CERTIFICATE OF APPROPRIATENESS

Property: 1323 South Blvd, Lot 3, Broadacres Neighborhood Subdivision. The property includes a historic 4,034 square foot, two-story single-family residence and a 1,507 detached garage situated on a 56,640 square foot (236' x 240') interior lot.

Proposal: Alteration – Addition, Windows

HOA LETTER OF SUPPORT

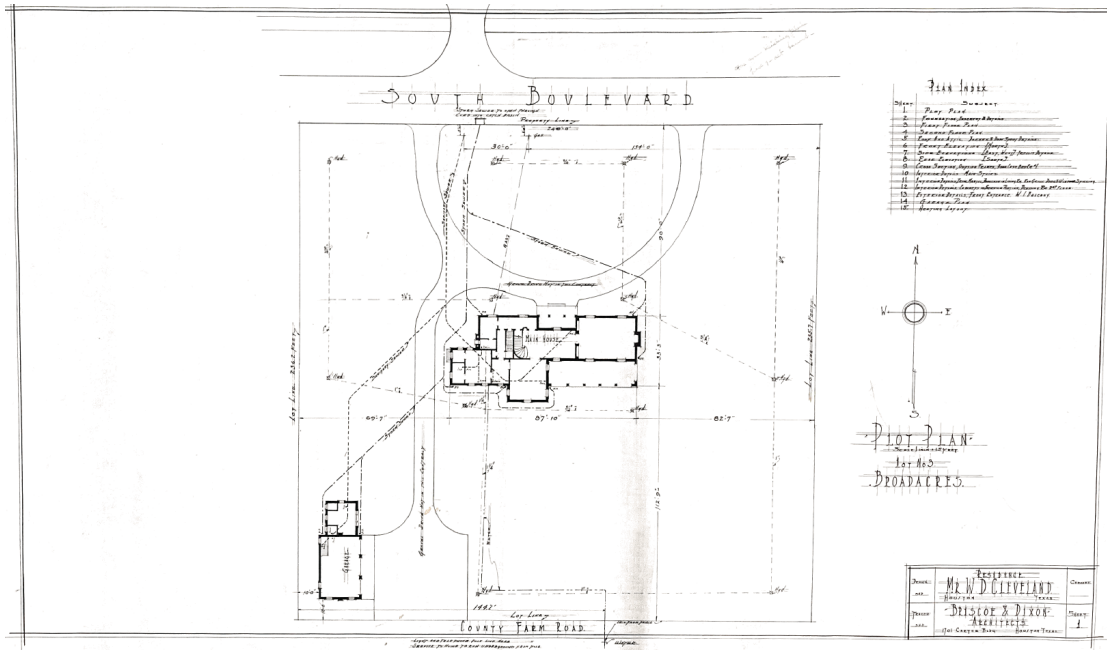
The Broadacres Architectural Committee approves the attached drawings for the historic renovation of 1323 South Blvd.

Dillon Kyle Architects has been in communication with the Broadacres Architectural Committee to review the 1323 South Blvd homeowners' vision of restoring the original architecture of the front facing facade as well as the expansion of the home.

We are grateful for this vision as the home's front facing facade has been altered from a design perspective. They are planning to remove windows that are not in keeping with the home and replacing the windows to match the original 1923 design intent. Note that they are wanting to add windows to the east elevation of the original home which I'm sure you will need to approve (noted on page 10). You will also see their demo plan, including the demolition of the carriage house which they believe has been altered over time.
